**TO: NORTH EAST TEXAS REGIONAL WATER PLANNING GROUP**

**FROM: DAWN PILCHER, P.E., LJA ENGINEERING, AND DAVID DUNN, P.E., HRD ENGINEERS, ON BEHALF OF RIVERBEND WATER RESOURCES DISTRICT**

**RE: SEDIMENT ACCUMULATION IN WRIGHT PATMAN LAKE**

**Figure 1. Wright Patman Lake Operating Rule Curves**

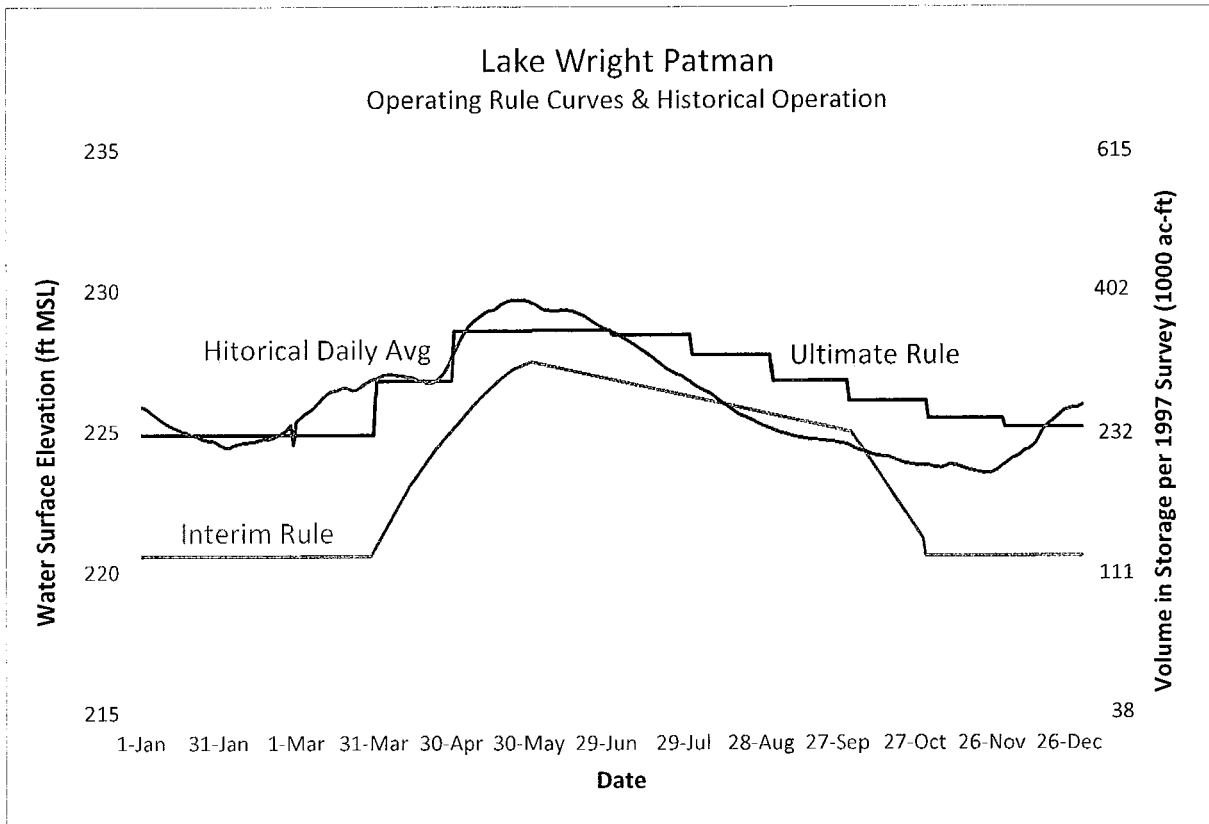
The dark blue line in Figure 1 represents the Ultimate Rule Curve with a minimum top of conservation of 224.89 feet msl from January through March which rises to 228.61 feet msl in June and 228.64 in July. The Ultimate Rule Curve provides for a minimum of 120,000 acre-feet of water supply storage in the winter to a maximum of 241,600 acre-feet of summer time conservation supply above elevation 220.0 feet msl for permanent water supply storage. The effective date for water withdrawal from Wright Patman Lake is the later of 1) the date of the deliberate impoundment of Cooper Lake (now Jim Chapman Lake), or 2) the date of completion of all modifications to Wright Patman Lake are required to effect the conversion of flood control storage to water supply storage and provides permanent rights to storage for water supply use.

The Permanent Contract is not currently in effect as all modifications required to effect the conversion of flood control storage at Wright Patman Lake have not been complete; however, **the Ultimate Rule Curve is the appropriate operating scenario when determining the firm yield of Wright Patman Lake for planning purposes**, because the Ultimate Rule Curve is specified in the water right (Certificate of Adjudication CA 03-4836) authorizing impoundment and use of water from the lake by the Texas Commission on Environmental Quality (TCEQ). Although the Texas Water Development Board (TWDB) planning guidelines would allow the Region D Planning Group to constrain the water supplies available from Wright Patman Lake to the Interim Rule Curve, it is the preference of Riverbend to utilize the Ultimate Rule Curve as the basis of its local supply and thereby maintain consistency with the established water rights issued from the lake and the current TCEQ Water Availability Model for the Sulphur River Basin. While the Ultimate Rule Curve has not been officially implemented, the U.S. Army Corps of

Engineers normally operates this project to closely mimic the Ultimate Rule Curve rather than the Interim Curve as evidenced in the green line in Figure 1, above. Finally, Riverbend is currently working with the USACE to begin studies that will facilitate official implementation of the Ultimate Rule Curve. If Region D continues to limit the yield of Wright Patman Lake by utilizing the Interim Rule Curve, then Riverbend requests that the Region D Planning Group clearly identify implementing the Ultimate Rule Curve as a strategy for increasing available supply in the region.

1. To maintain consistency with the current water rights permit and the TCEQ model of the Sulphur River Basin, the Ultimate Rule Curve should be used as the appropriate operating scenario when determining firm yield supplies available from Wright Patman Lake and when analyzing impacts of sedimentation.
